BID ADDENDUM #2

Date: July 28, 2025

Project: RUHS Cardiac Catheterization Lab Suite & Hyperbaric Facility Expansion

Re: Bid Addendum #2

D1 PARTIAL ROOF PLAN
SCALE: 1/8" = 1'-0"

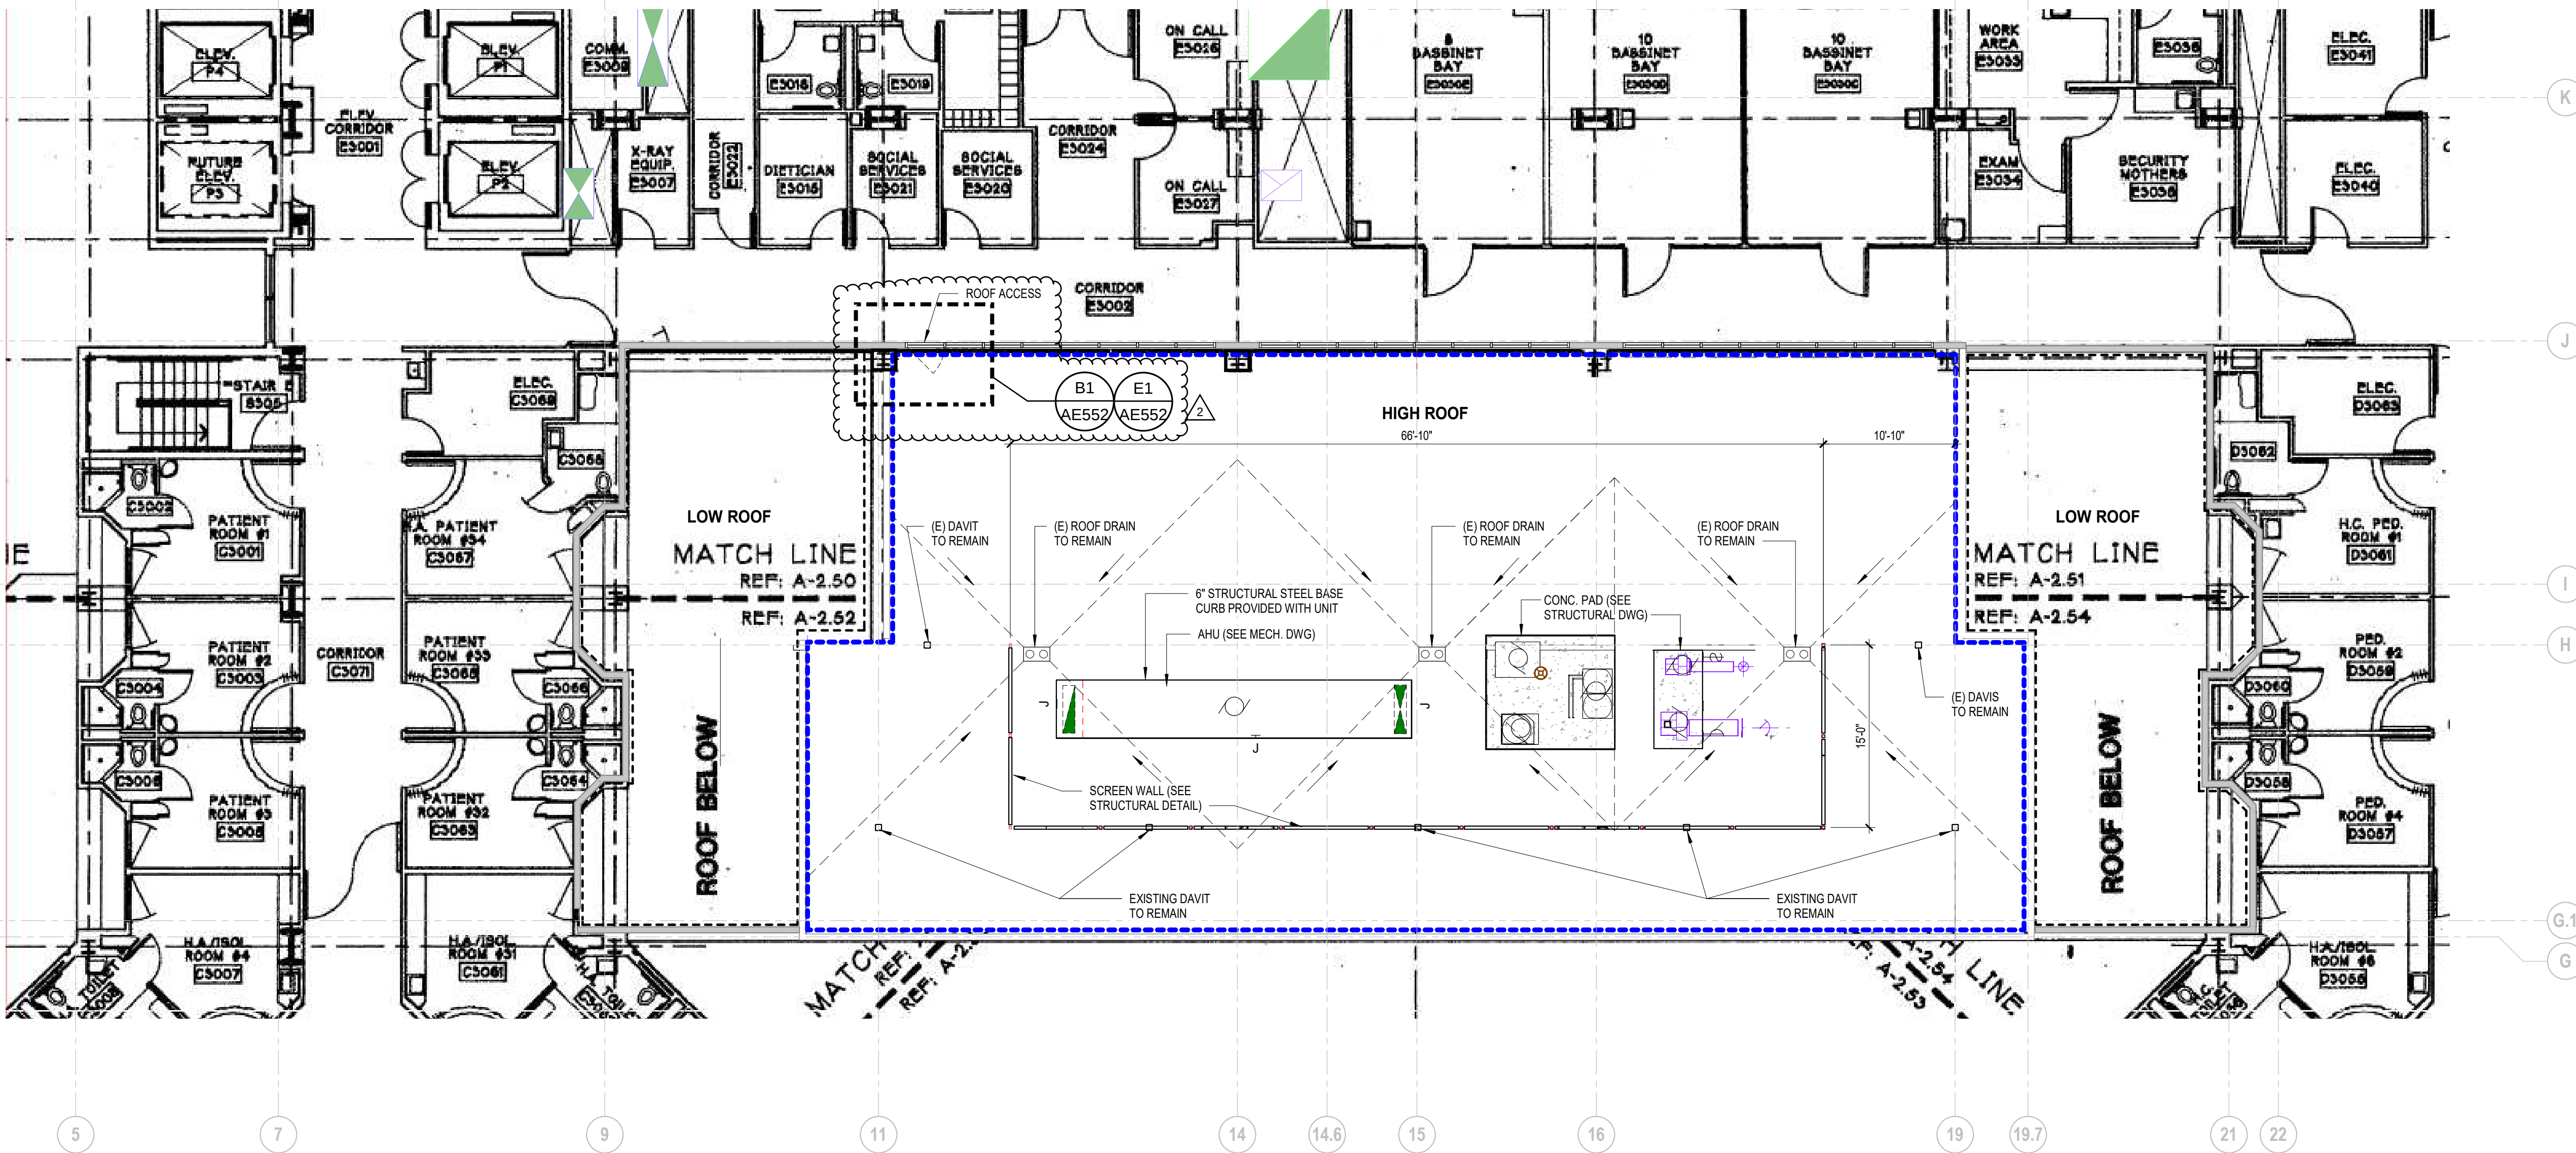
1. Located new 3rd floor roof maintenance access door on D1/AE112 Partial Roof Plan. Added detail references for demo and remodel scope on new sheet AE552.

SHEET NUMBER
AE552

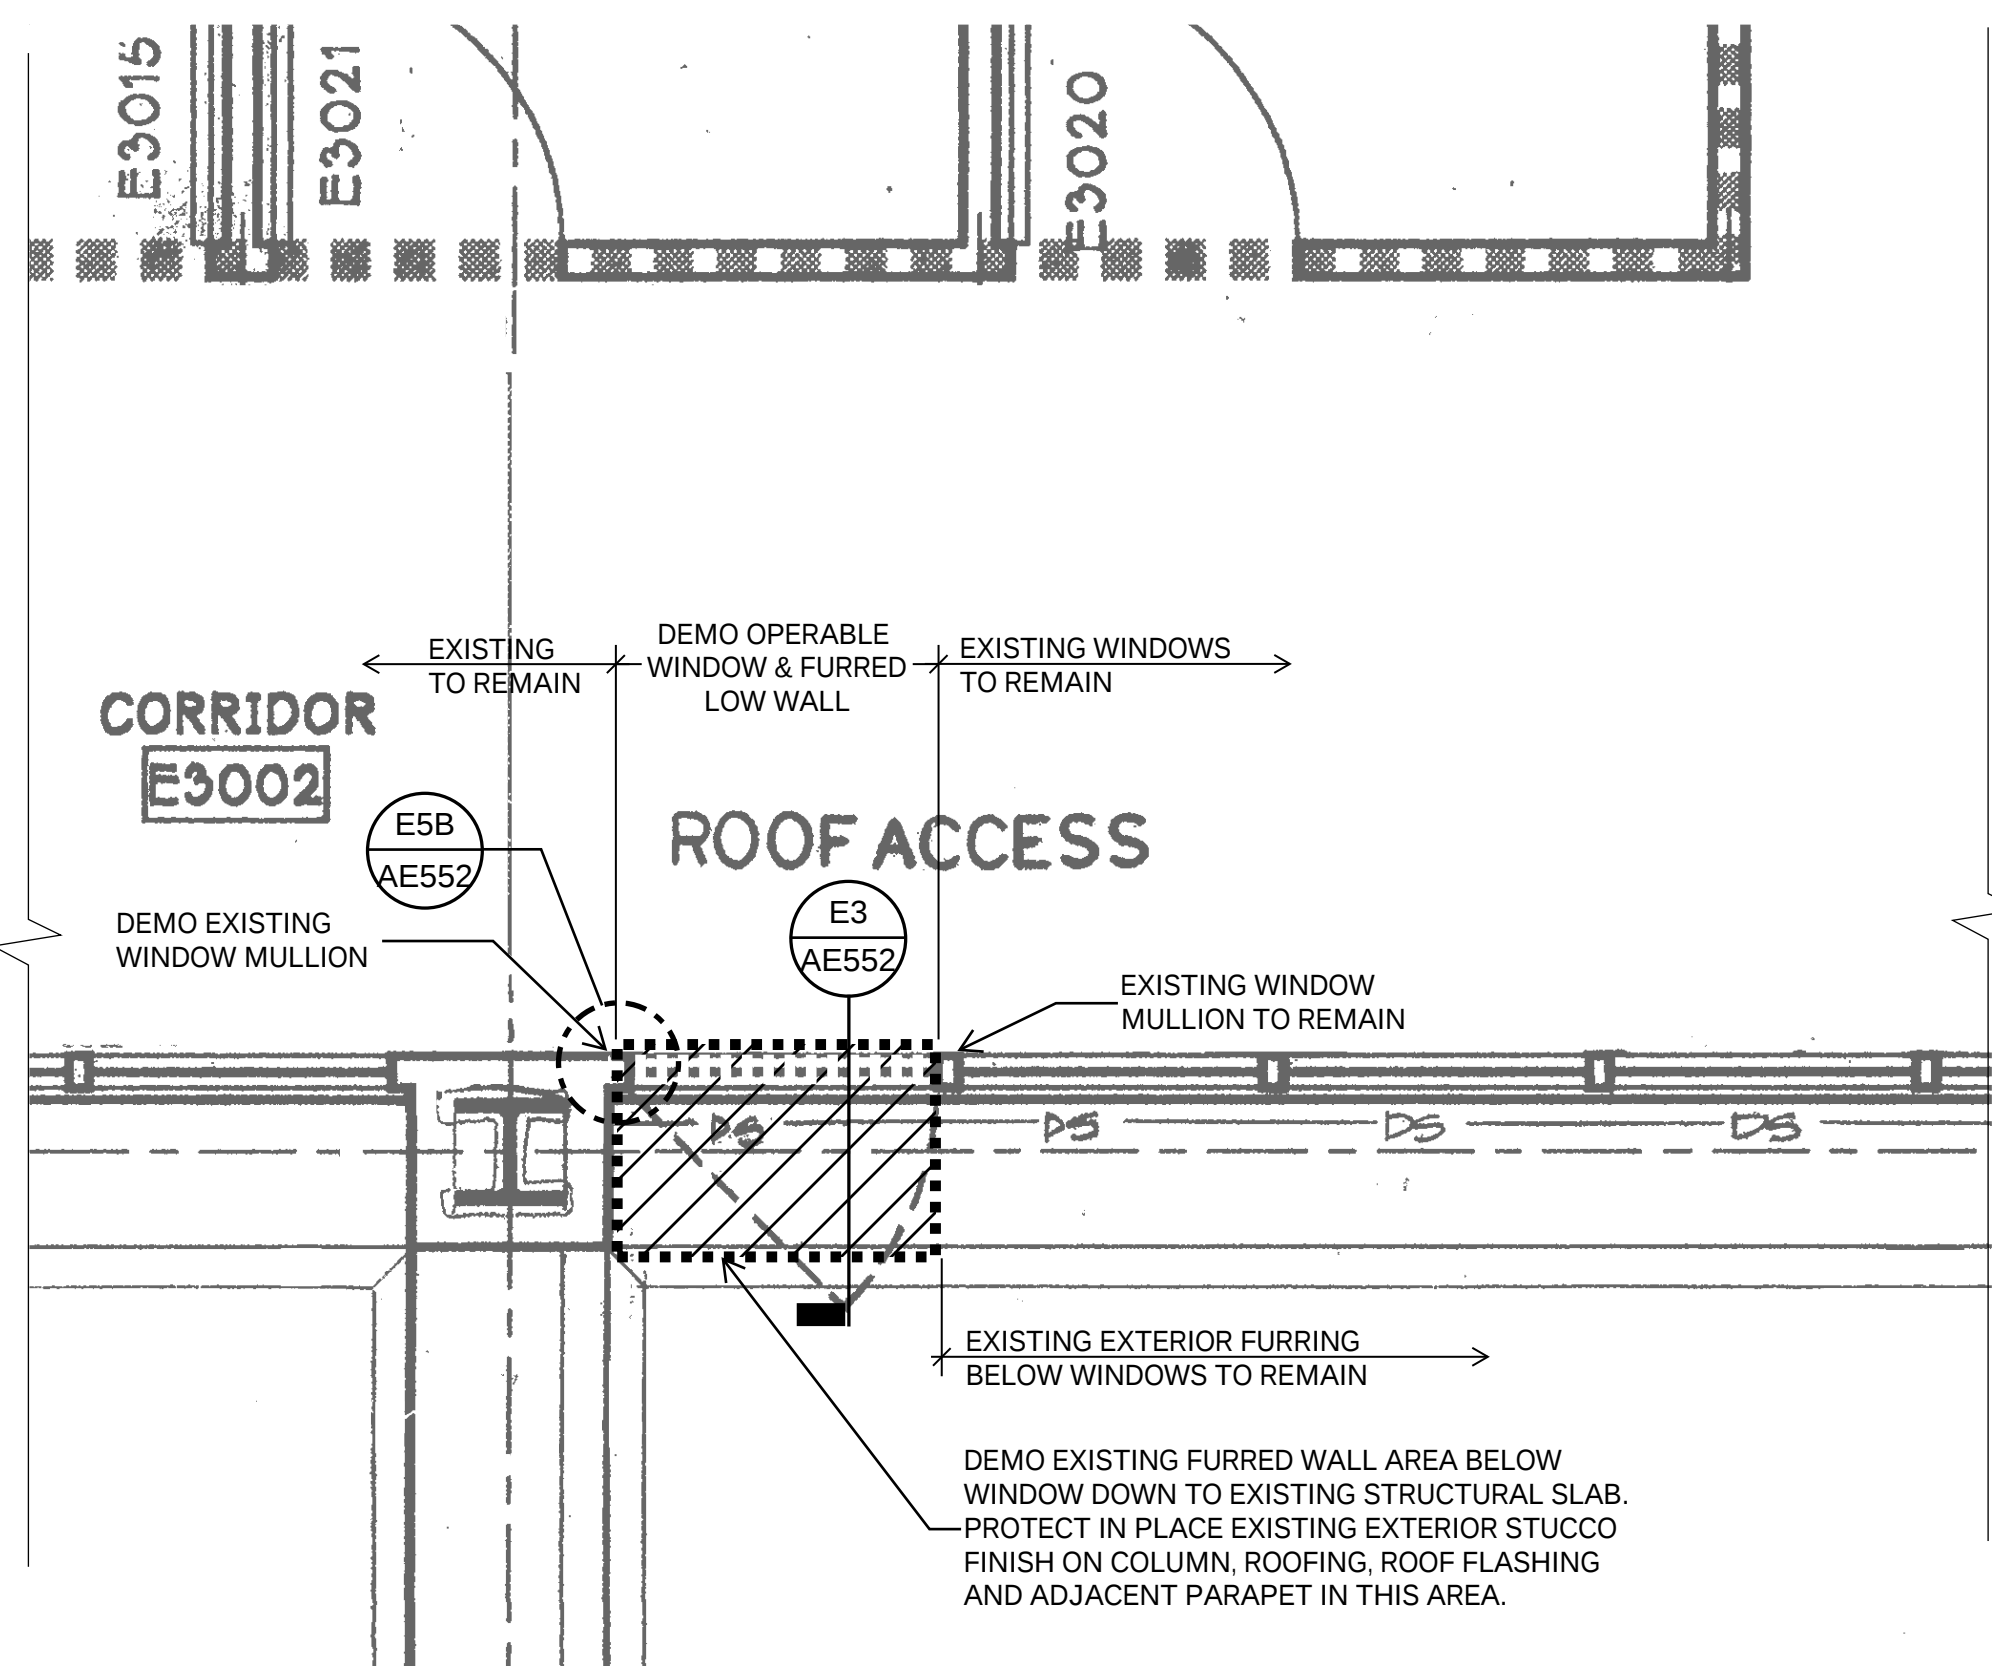
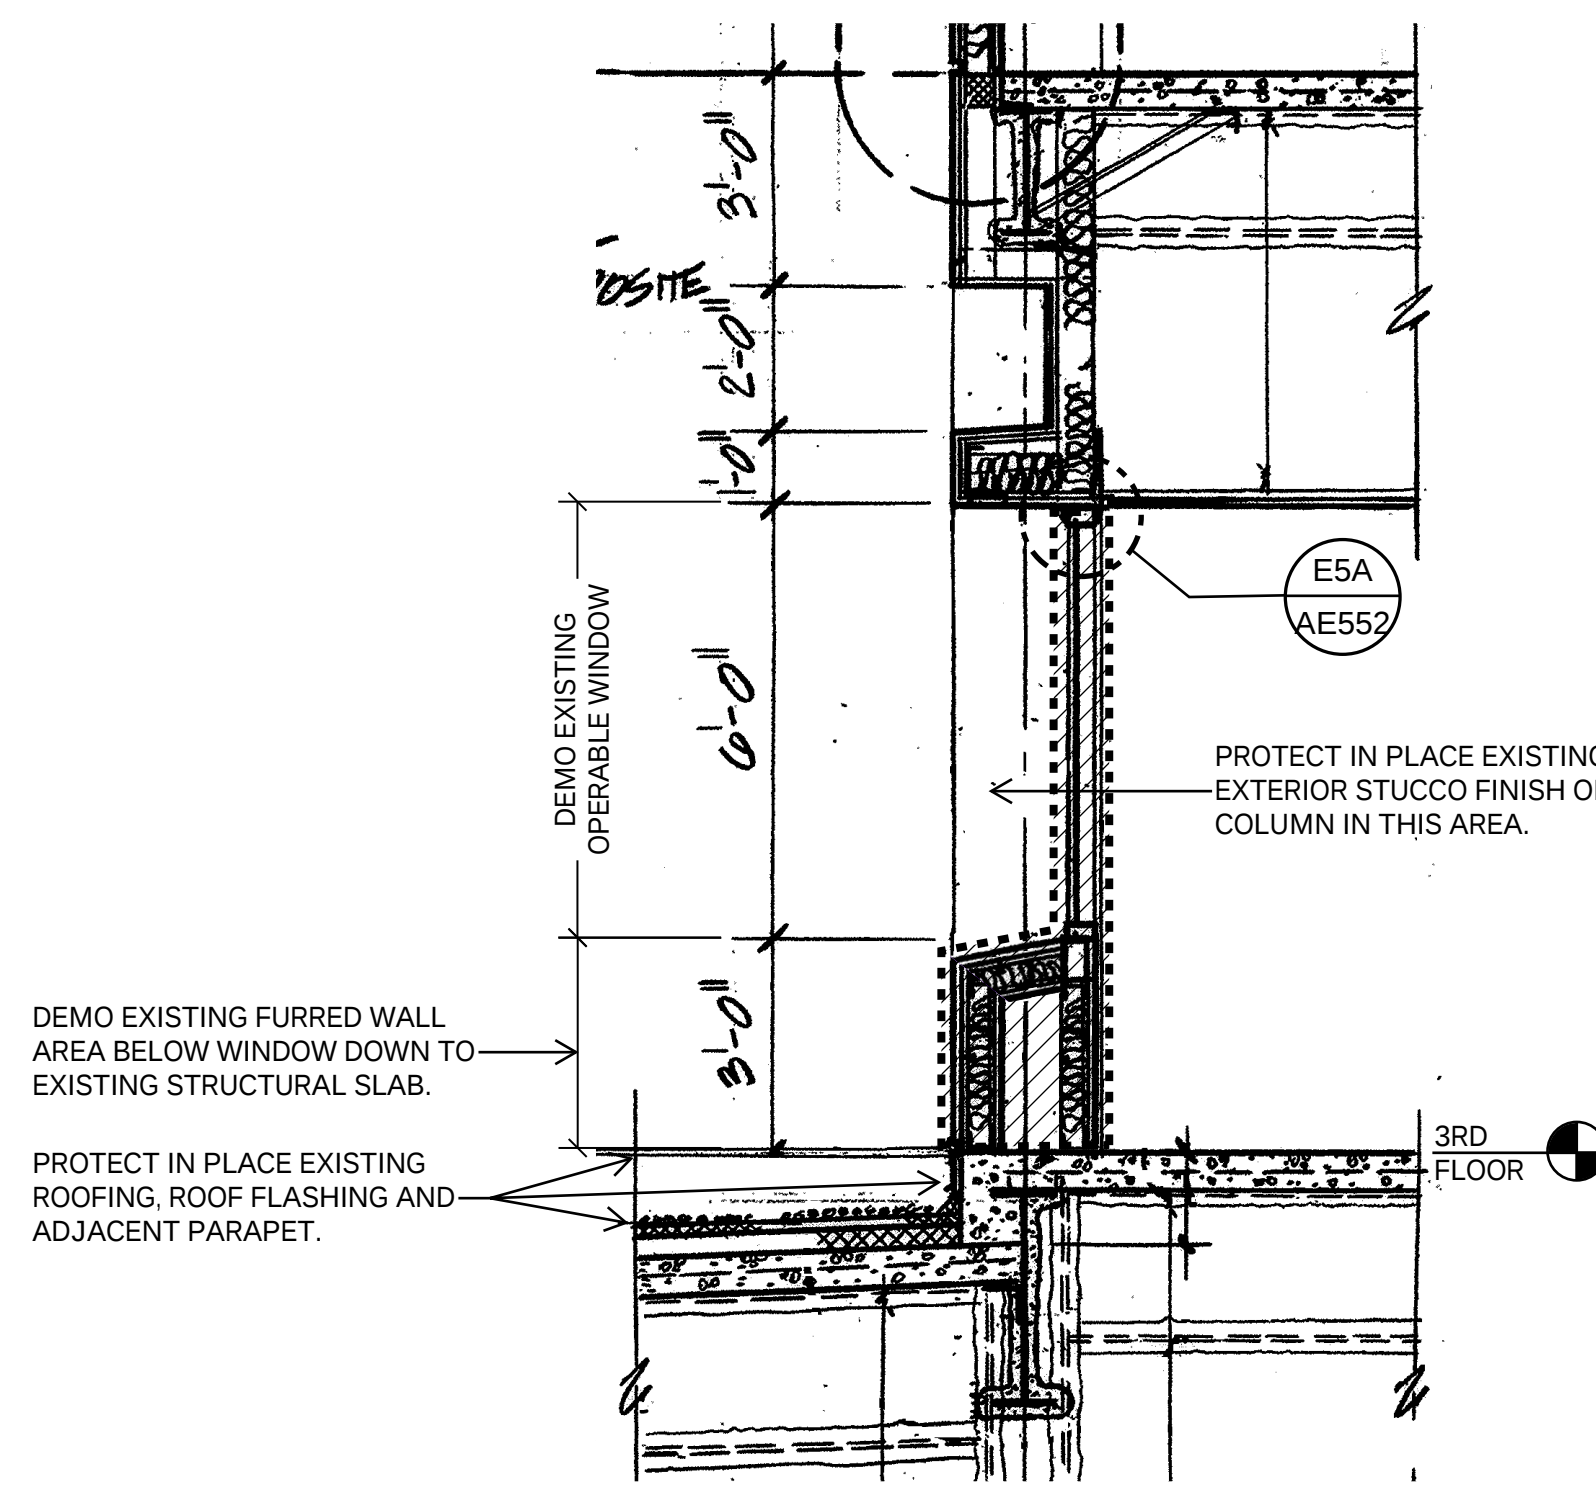
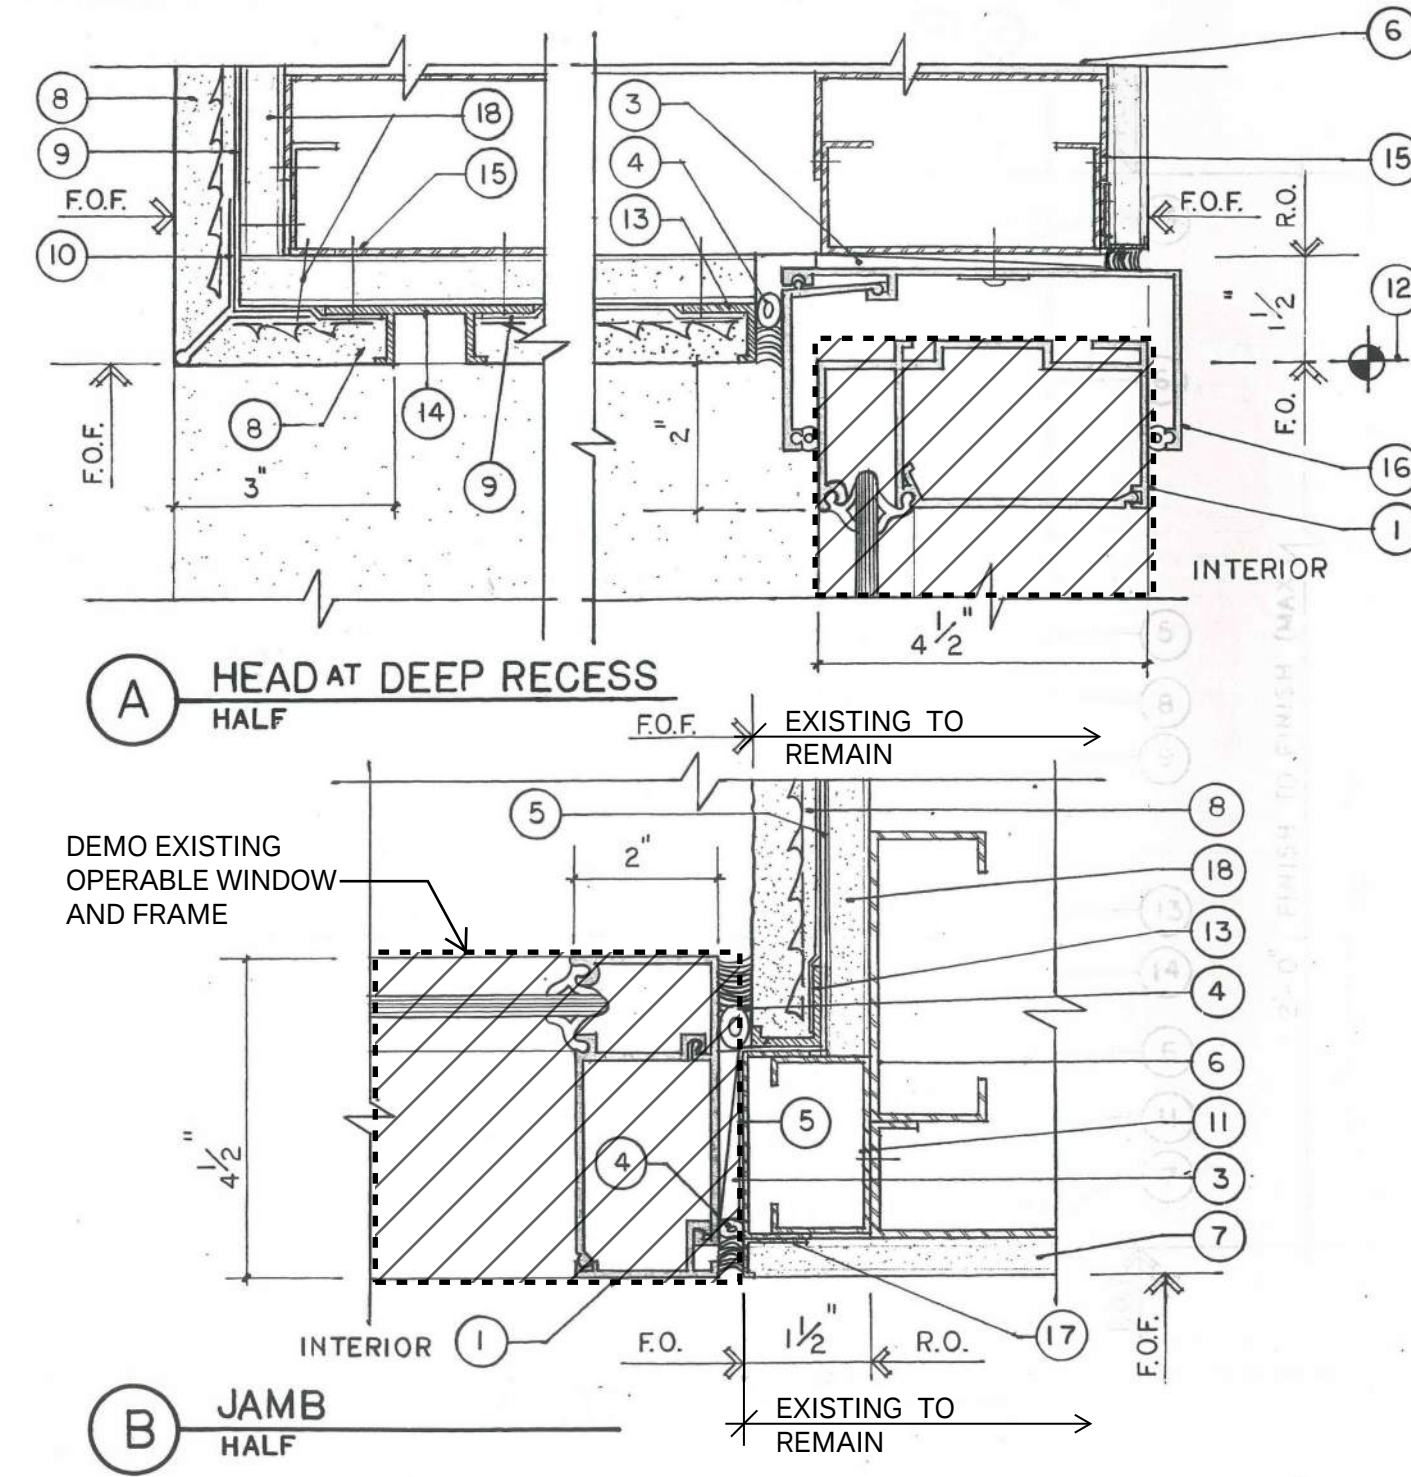
2. New demo plans and details describing the demo of an existing roof access hatch in the existing exterior storefront window and a portion of the exterior furred wall below the window.
3. New remodel plans and details describing the installation of a new roof access doorway within a single window bay of the existing exterior window system.
